**Name:** Morné de Jager  
**Cell:** 082 565 4059  
**E-mail:** morne@menco.co.za  
**Date:** 5 February 2019  
**Ref:** Great Karoo WEF change

**SPECIALIST STUDY: NOISE IMPACT ASSESSMENT: PROPOSED GREAT KAROO WIND ENERGY FACILITY NEAR SUTHERLAND: CHANGE OF WIND TURBINE LAYOUT AND SPECIFICATIONS**

Figure 1: Previous and new locations of the wind turbines for the proposed wind farm

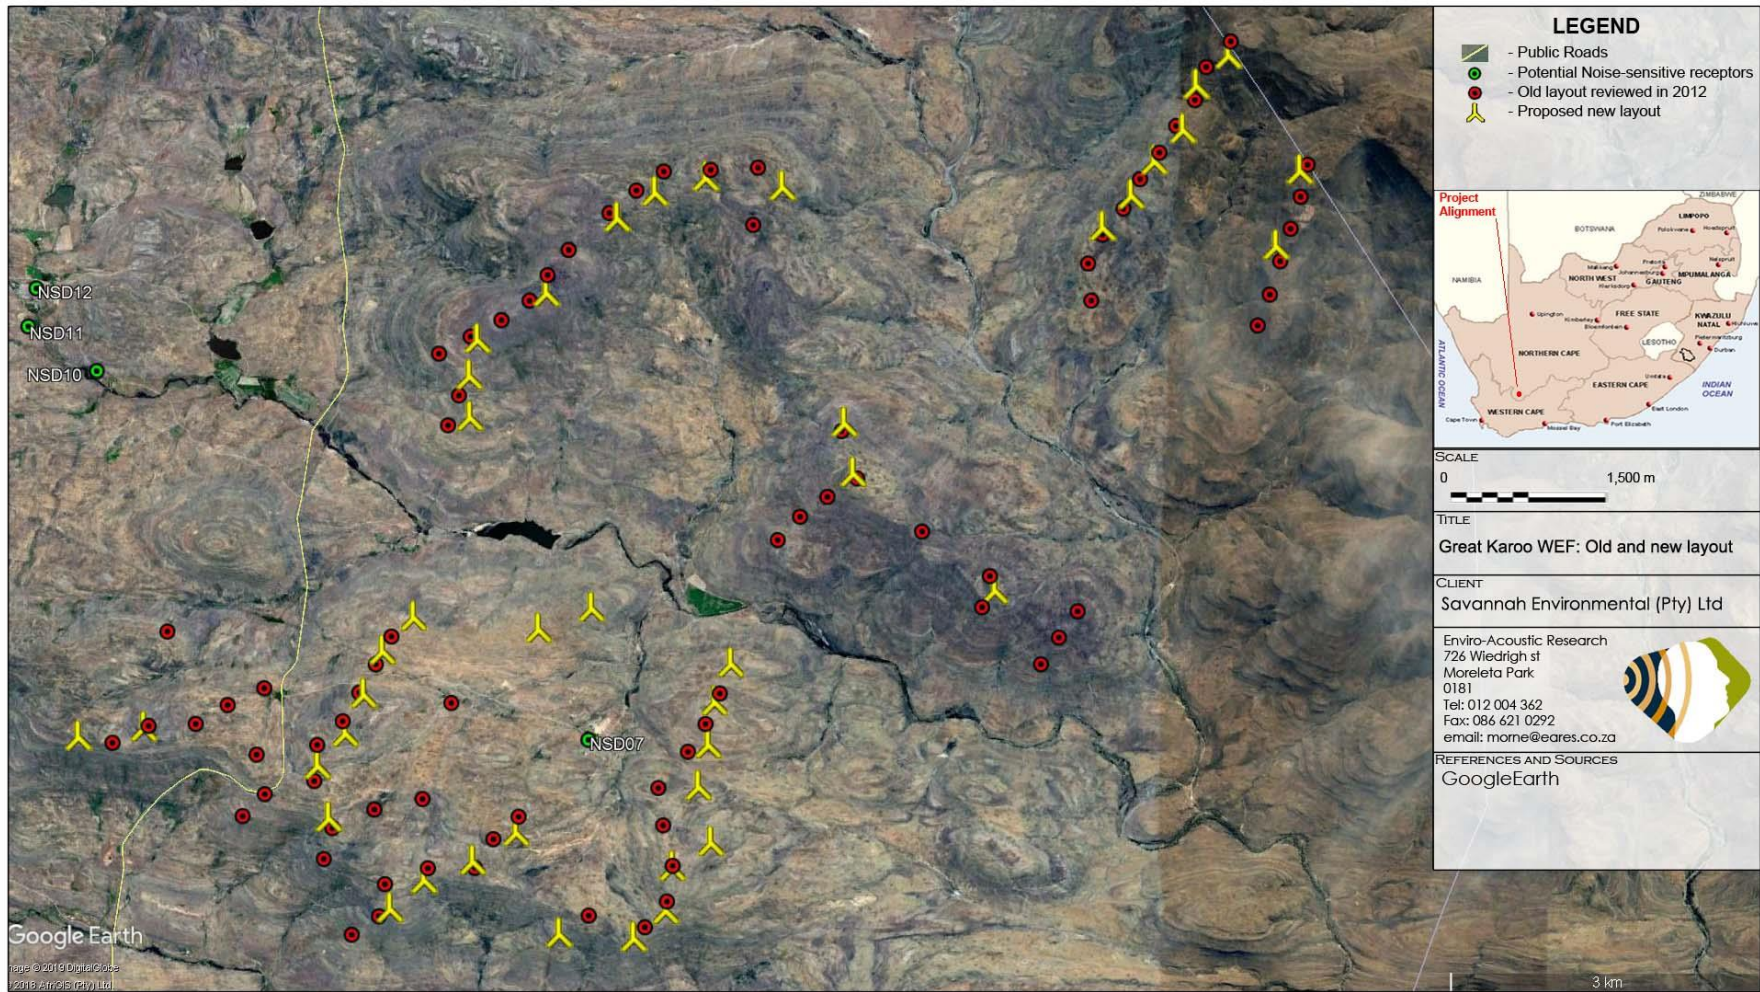
The updated layout locates the closest WTG 1,090m from NSD07, with eight WTG located within 1,500m from this NSD. The wind turbines (of the new layout) are on average slightly further from this potential noise sensitive receptor.

Considering the location of the wind turbines and the potential noise impact, it is my opinion that the change will not increase the significance of the noise impact, subject that a wind turbine with a maximum sound power emission level of 107 dBA are used by the developer. A full noise impact assessment with new modeling will not be required and the recommendations as contained in the previous document will still be valid.

If the developer selects a wind turbine generator with a sound power emission level exceeding 107 dBA, the noise impact assessment must be reviewed in detail.
